RE: Docket No. 06-AFP-1 Alternative Transportation Fuels Plan Full Fuel Cycle Assessment

Attached please find Shell Oil Company's comments concerning TIAX's "Full Fuel Cycle Analysis Assessment" (CEC publication numbers: CEC-600-2007-002-D, CEC-600-2007-003-D, and CEC-600-2007-004-D).

# Review of TIAX LLC's WtW Study of Alternative Fuels & Vehicles

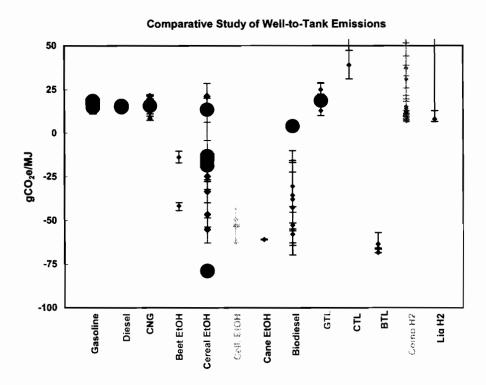
The graph below compares selected TIAX WtT data with results from the JEC study and the GM-Argonne study. The purpose of this graph is **not** to compare values (which would be misleading in light of the the cautions in Section 2) but instead to point out the wide range in WtT emissions possible for a single fuel product depending on the specific assumptions about the pathway including the feedstock and manufacturing methods and the treatement of coproducts.
